INDEPENDENT ORBITER ASSESSMENT ✓

**FMEA/CIL
ASSESSMENT
INTERIM REPORT**

9 MARCH 1988

WORKING PAPER NO. 1.0-WP-VA88003-40

Figure C.2b - RSB ACTUATOR ASSESSMENT

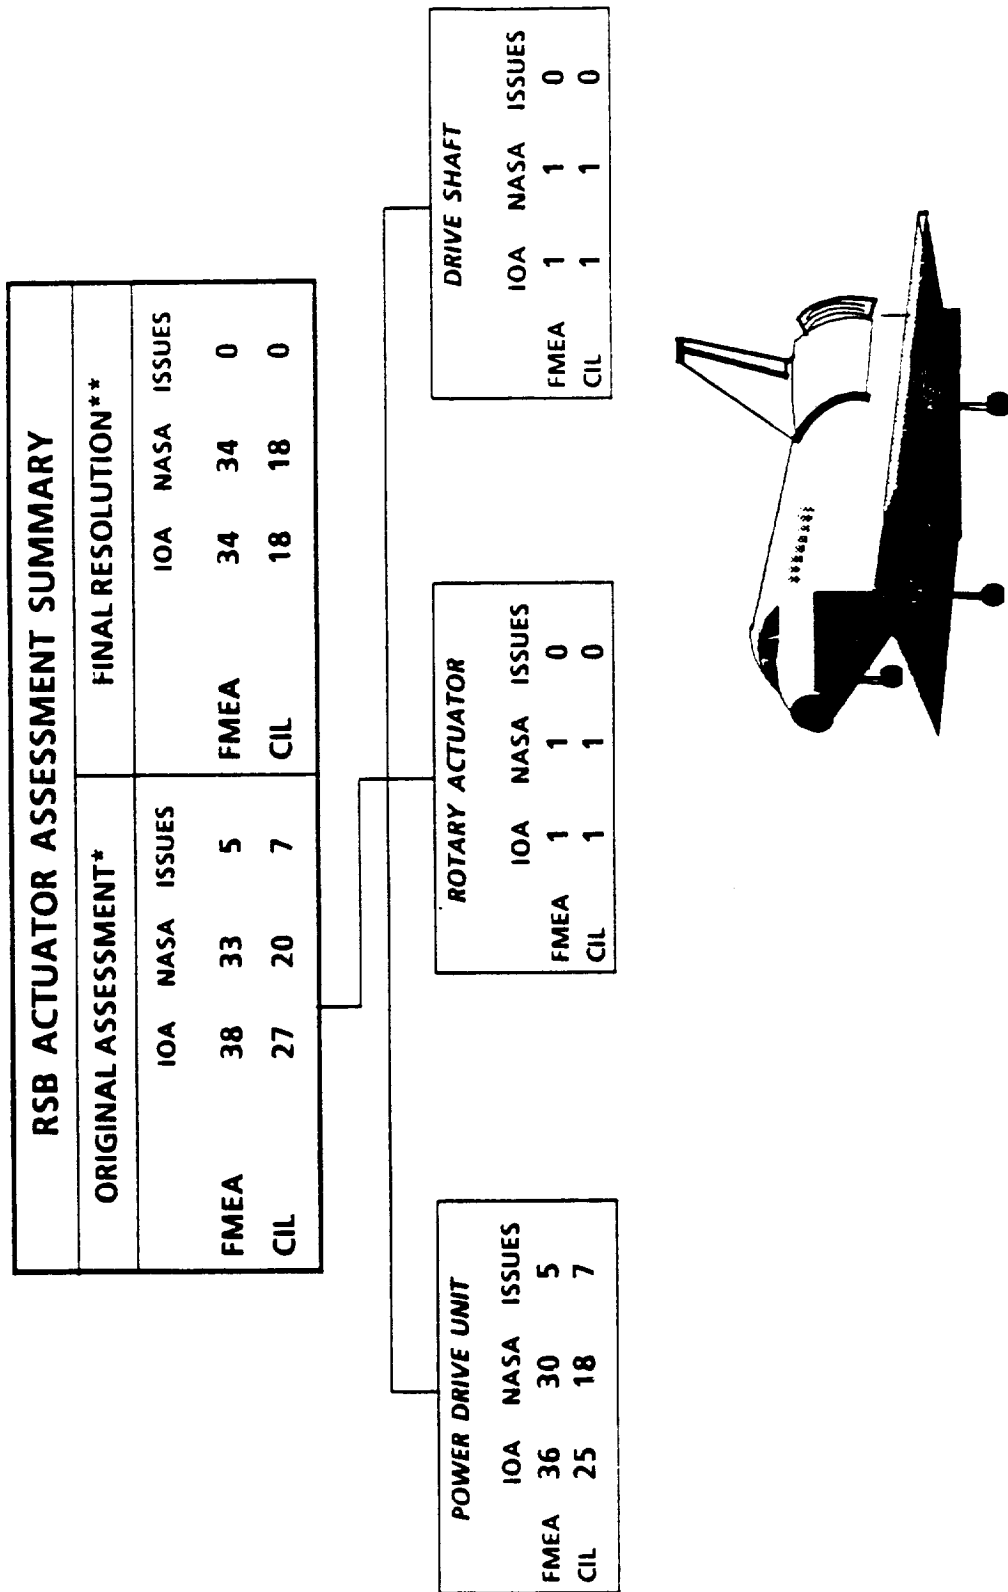
The overview in Fig. C.2b is a summary of the RSB actuator assessment and presents a comparison of the Pre 51-L baseline and the proposed Post 51-L baseline, with the IOA recommended failures, and any issues. The main reason for differences was that NASA combined failures, whereas IOA prepared separate failure worksheets. Minor differences such as fail or pass of screens were readily resolved. As the result of discussions with the Subsystem Manager and review of the updated FMEA/CIL, all initial issues were resolved and changes were made to the FMEA/CIL and IOA worksheets. The overview further shows the comparison of failures of the major elements of the RSB actuators.

The IOA effort first completed an analysis of the Rudder/Speed Brake (RSB) hardware, generating draft failure modes and PCIs. To preserve independence, this analysis was accomplished without reliance upon the results contained within the NASA FMEA/CIL documentation.

The IOA analysis of the RSB hardware initially generated 38 failure mode worksheets and identified 27 PCIs before starting the assessment process. No additional failure mode worksheets were generated during the comparison. The IOA results were then compared to the NASA FMEA/CIL baseline along with the proposed Post 51-L CIL updates included. A resolution of each discrepancy from the comparison was provided through additional analysis as required. Upon completion of the assessment, all of the IOA and NASA failure modes were in agreement.

Figure C.3 - D&C OVERVIEW ASSESSMENT

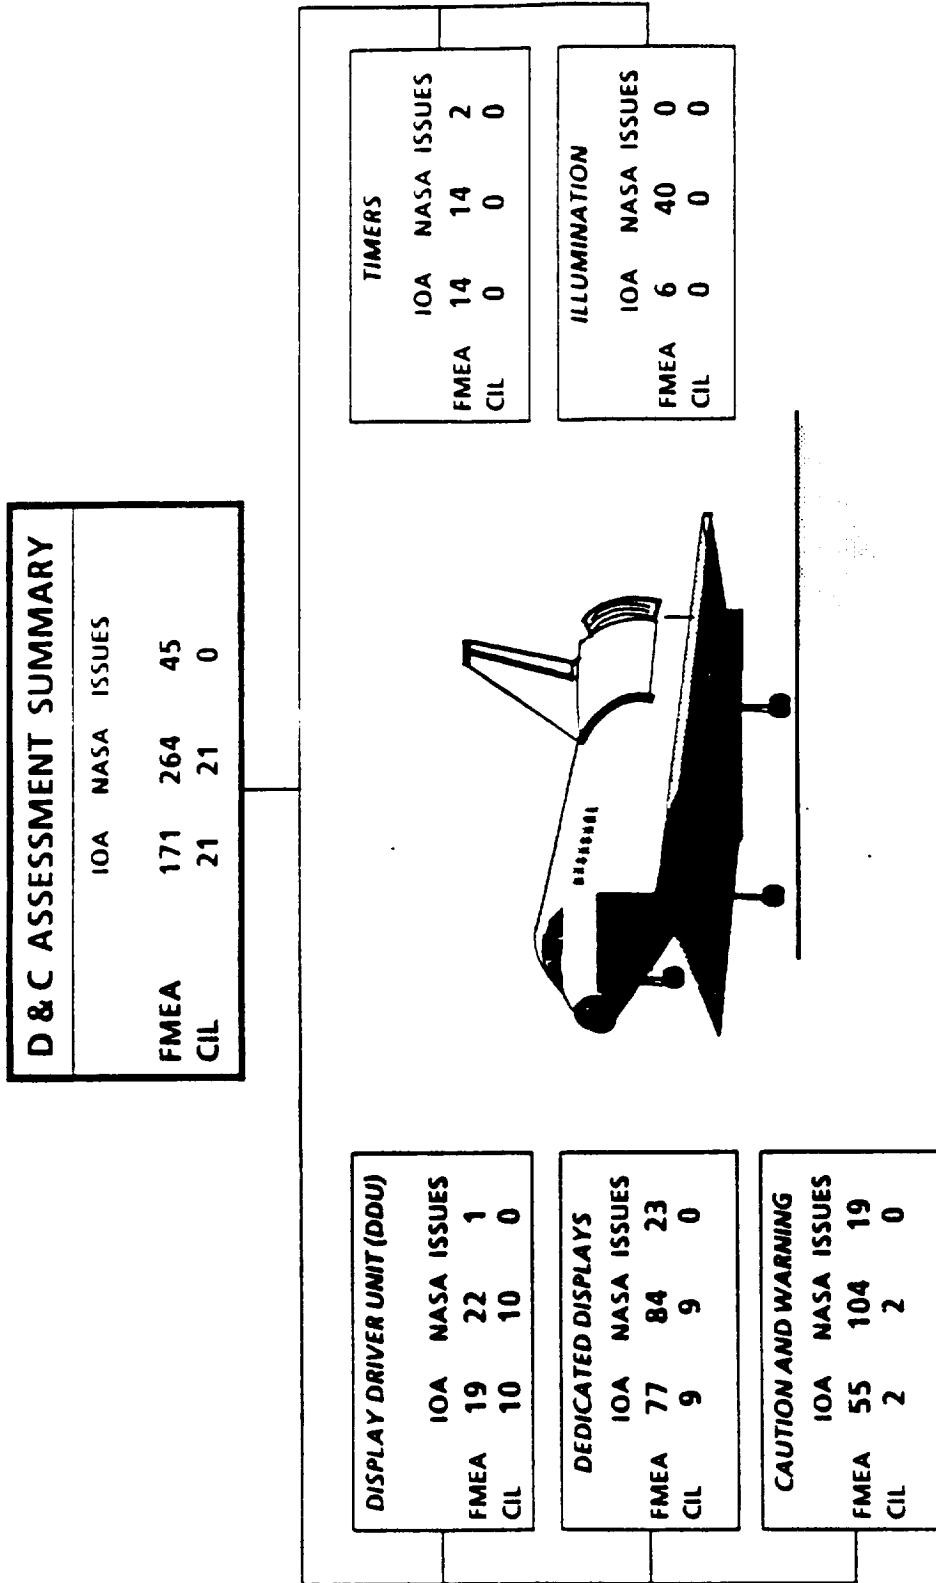
The IOA product for D&C analysis consisted of 134 failure mode worksheets that resulted in 8 PCIs being identified. In order to facilitate comparison, 37 additional failure mode worksheets were generated. Comparison was made to the NASA baseline of 4 January 1988, which consisted of 264 FMEAs and 21 CIL items. The comparison determined if there were any results which had been found by the IOA but were not in the NASA baseline. This comparison produced agreement on all but 45 FMEAs, which caused no differences in the CIL items. Reference Figure C.3.

The issues arose due to different interpretation of NSTS 22206, FMEA and CIL preparation instruction. IOA analyzed the electrical circuit as a black box, and NASA analyzed the components of the black boxes. Of the 45 differences with the FMEAs, all were minor and did not affect criticalities assessment. In conclusion, IOA is in full agreement with the revised NASA CIL baseline.

Figure C.4a - GNC FMEA/CIL ASSESSMENT

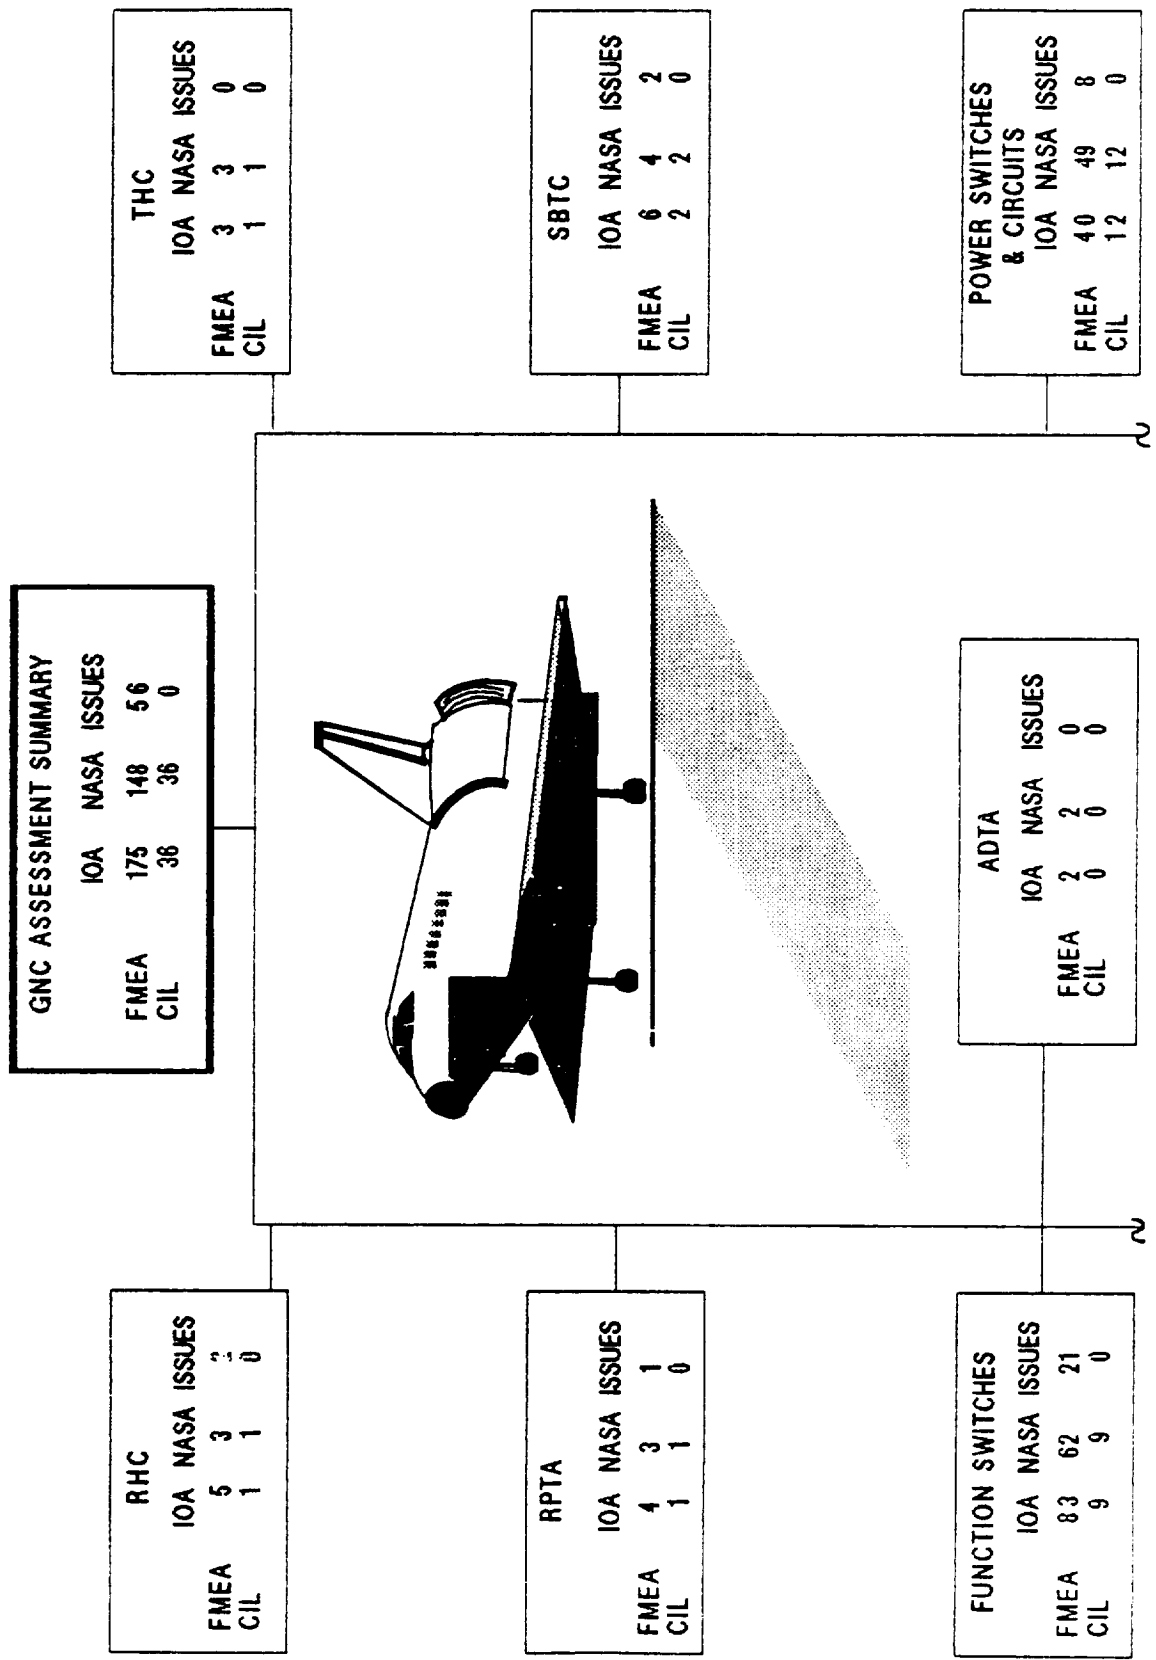
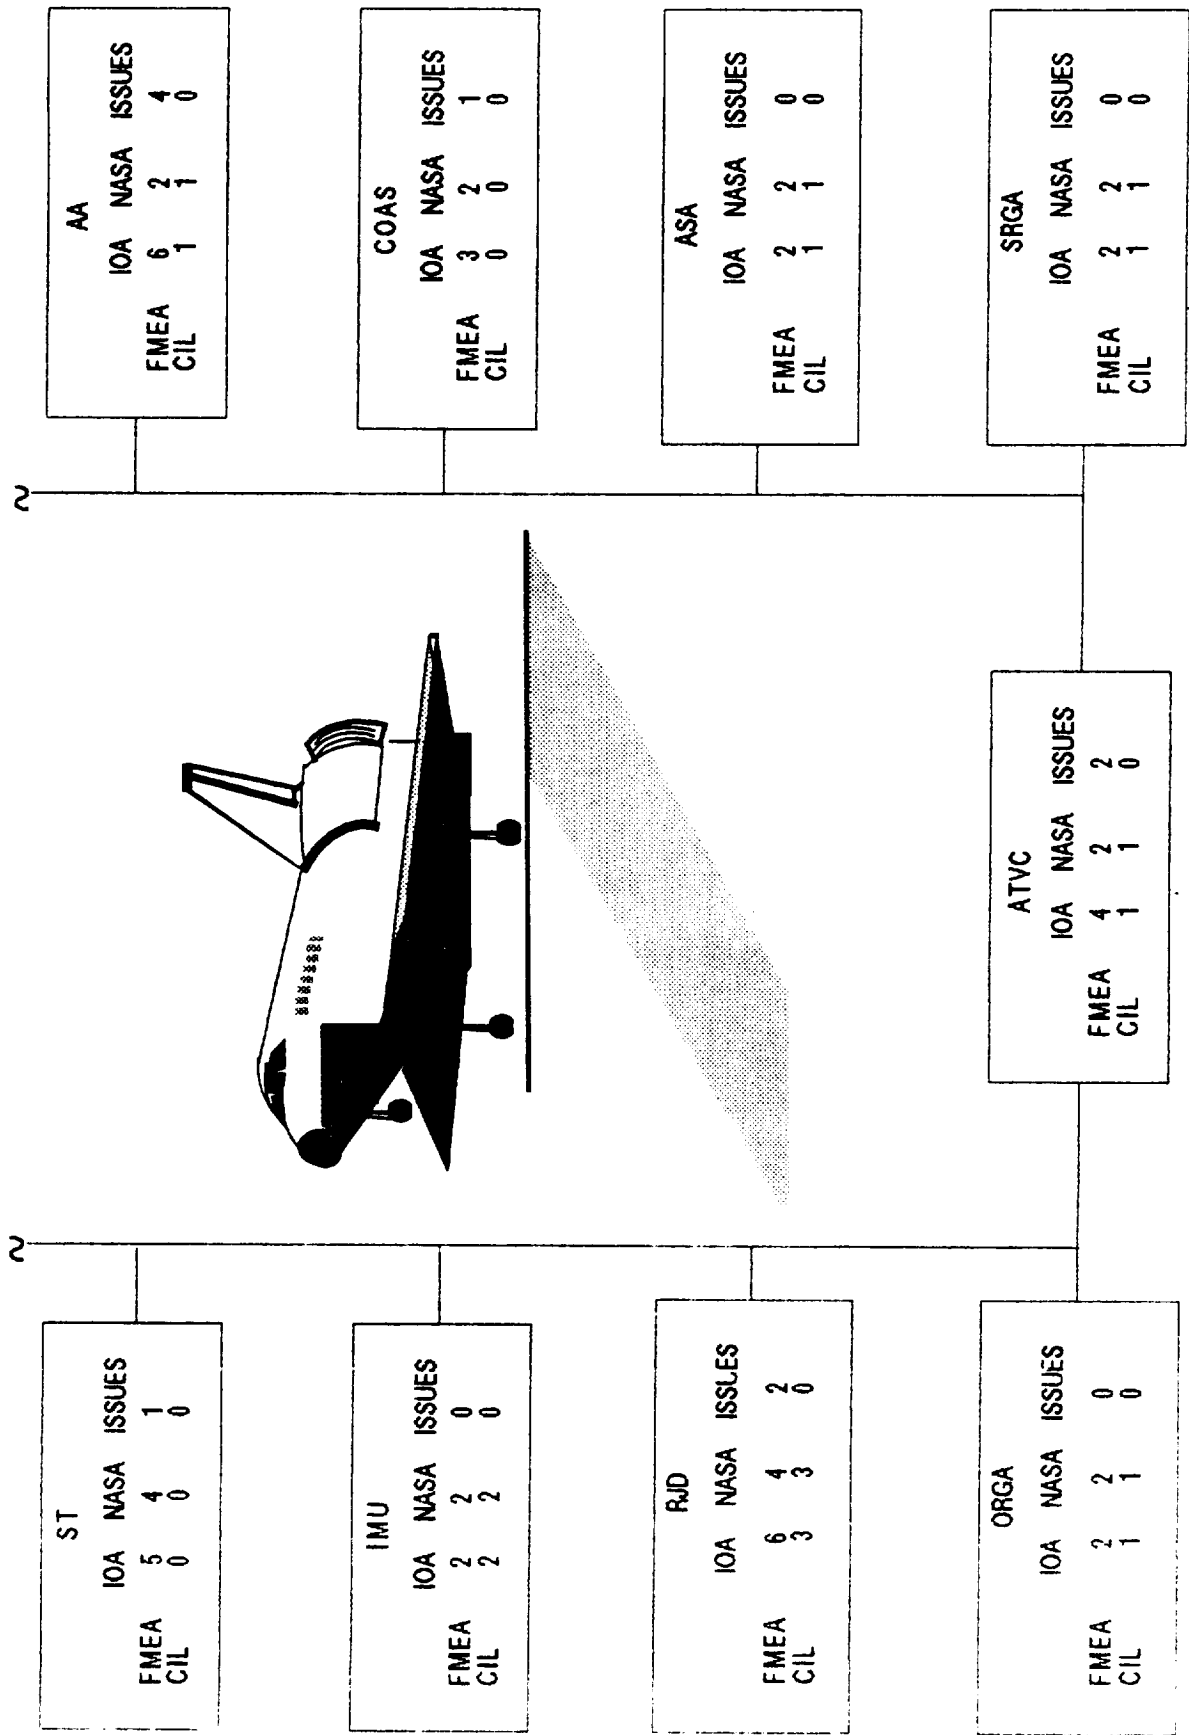
The IOA product for the GNC analysis consisted of 141 failure mode worksheets that resulted in 24 PCIs being identified. In order to facilitate comparison, 34 additional failure mode worksheets were generated. Comparison was made to the NASA baseline (as of 4 January 1988) which consisted of 148 FMEAs and 36 CIL items. The comparison determined if there were any results which had been found by the IOA but were not in the NASA baseline. This comparison produced agreement on all but 56 FMEAs, which caused differences in zero (0) CIL items. Reference Figure C.4a & b.

The issues arose due to different interpretation of NSTS 22206, FMEA and CIL preparation instructions. IOA analyzed the components of the electrical circuits, generating 56 worksheets more than NASA, who treated the electrical circuits as black boxes. Of these 56 differences with the FMEAs, all were minor and did not affect criticalities assessments. Three (3) of the FMEAs' issues were with the SRB RGA's EPD&C. No drawings were available to assess these FMEAs. In conclusion, IOA is in full agreement with the revised NASA CIL baseline.

Figure C.7 - BFS FMEA/CIL ASSESSMENT

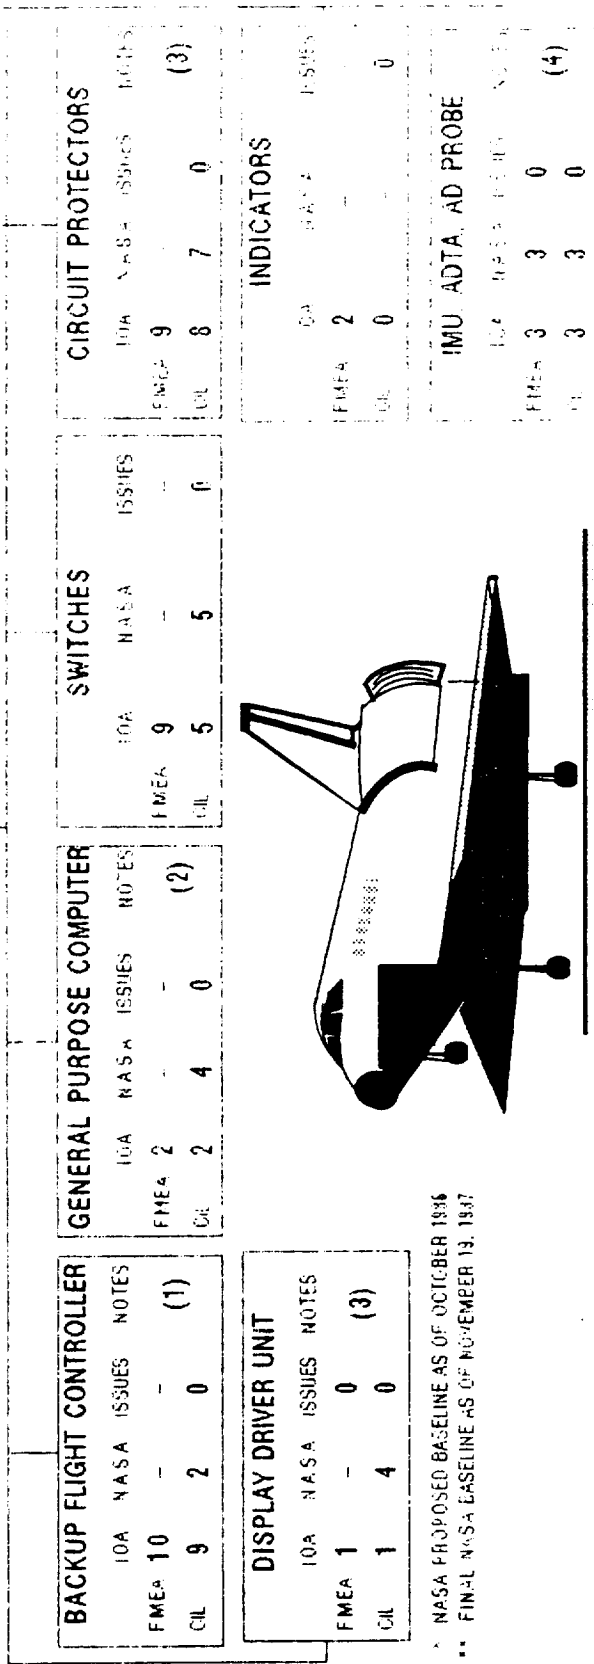
The original assessment determined there were numerous failure modes and PCIs in the IOA analysis that were not contained in the NASA BFS baseline. Conversely, the NASA baseline contained 3 FMEAs (IMU, ADTA, and Air Data Probe) for CIL items that were not identified in the IOA product. The IOA prepared worksheets and agreed with the NASA analysis for the 3 items. This increased the IOA worksheets from 29 to 32 and the PCIs from 21 to 24 for the original assessment as shown in Figure C.7.

a substantial rewrite of all CILs between December 1986 and November 1987. This effort included eliminating BFS as a unique subsystem by integrating BFS CILs with primary DPS CILs. The revised NASA baseline contained 4 more FMEAs for CIL items that were not identified in the original IOA BFS product, deleted the IMU CIL related FMEA mentioned in the previous paragraph, and moved the ADTA and Air Data Probe CILs also mentioned in the previous paragraph, to the GN&C subsystem. Once again, the IOA prepared worksheets and agreed with the NASA analysis of the additional failures. This increased the IOA worksheets from 32 to 33 and the PCIs from 24 to 25 for the final assessment. The IOA assessment of the final updated baseline (19 November 1987) results in agreement on all BFS CIL items, even though there are differences in number of items and assigned criticalities. Figure C.7 presents an overview of the assessment results.

The differences in assigned criticalities are due to different interpretation and application of the FMEA/CIL preparation instructions contained in NSTS 22206. The IOA analyzed BFS hardware failures with the assumption the BFS had been or would be engaged. NASA analyzed BFS hardware failures as an integral part of the DPS or EPD&C and, therefore, counted generic PASS failures when assigning criticalities to BFS hardware failure modes. The IOA interpretation neither added to, nor subtracted from the CIL.

Figure C.12a - ATCS FMEA/CIL ASSESSMENT

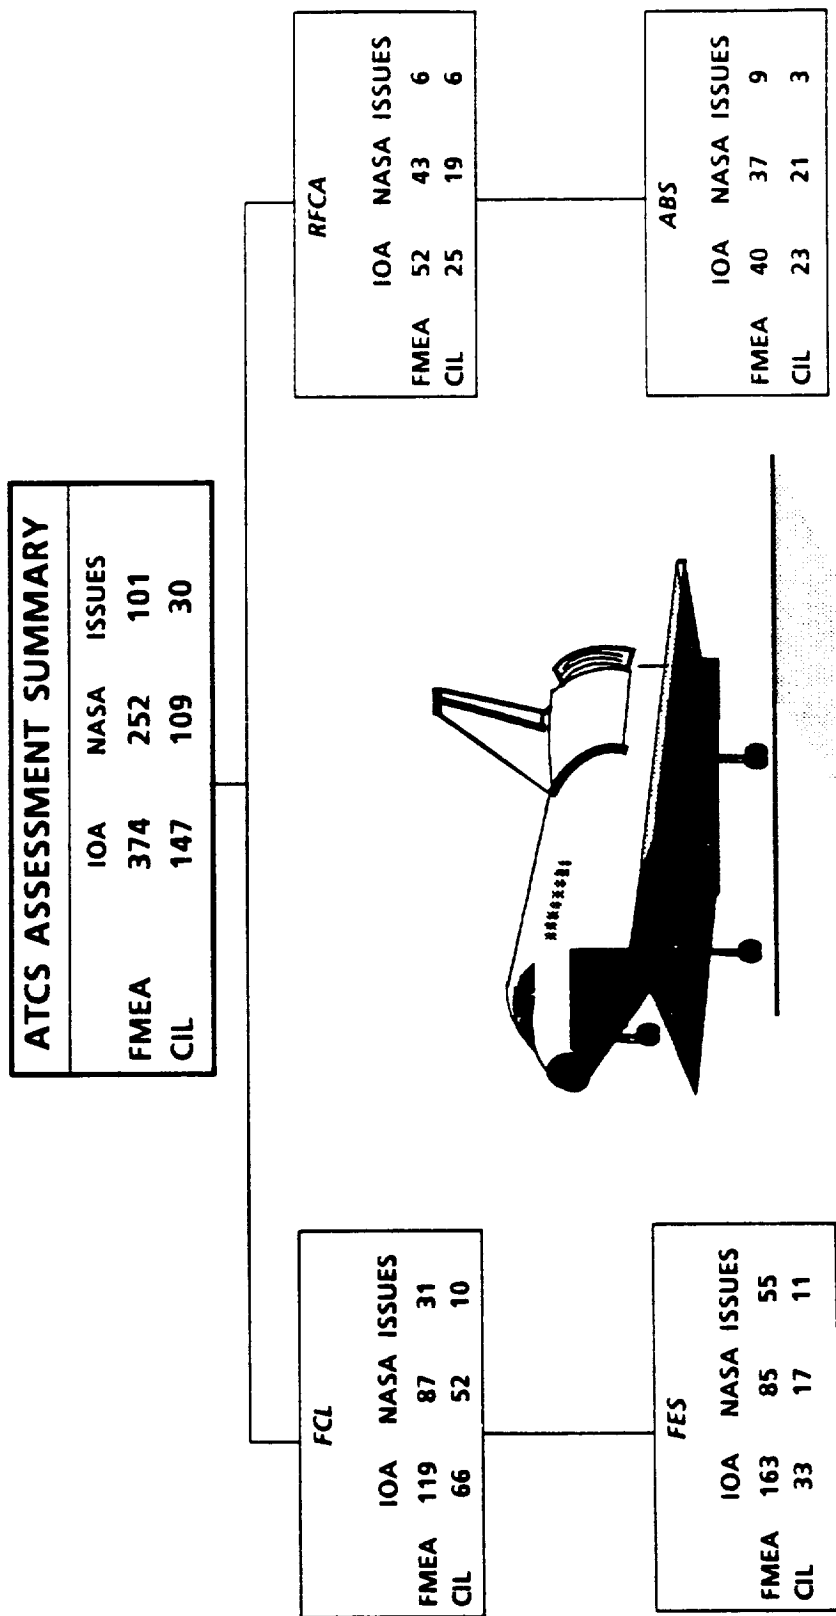
The ATCS Assessment Overview figure C.12a lists the total number of IOA and NASA FMEA and CIL items along with a comparison of the discrepancies or issues identified during the assessment. For analysis purposes, the ATCS was divided into 4 subsystems: the Freon Coolant Loop (FCL), the Radiator Flow Control Assembly (RFCA), the Flash Evaporator System (FES) and the Ammonia Boiler System (ABS).

The IOA analysis of the ATCS hardware initially generated 310 failure mode worksheets and identified 101 PCIs before starting the assessment process. In order to facilitate comparison, 74 additional failure mode worksheets were generated. Additionally, upon closer examination, IOA deemed 10 of the original failure modes to be non-credible and recommends deleting them. Thus, the final IOA analysis identified 374 FMEAs and 147 potential CILs. The analysis results were compared to the available NASA FMEA/CIL data. A total of 252 NASA FMEAs and 109 NASA CILs were identified. The discrepancy between the number of IOA and NASA FMEAs can be explained by the different approaches used by NASA and IOA to group failure modes. This resulted in multiple IOA FMEAs being mapped to a single NASA FMEA. However, every NASA FMEA is mapped to at least 1 IOA worksheet. A total of 101 FMEA and 30 CIL issues were identified on the ATCS. A number of these issues involved failures which were identified by IOA but not by NASA. These included external leakage of heat exchanger fluid and external leakage of water/steam from the FES ducts. These failures plus the remaining issues should be examined by NASA and included in the FMEA package as required.
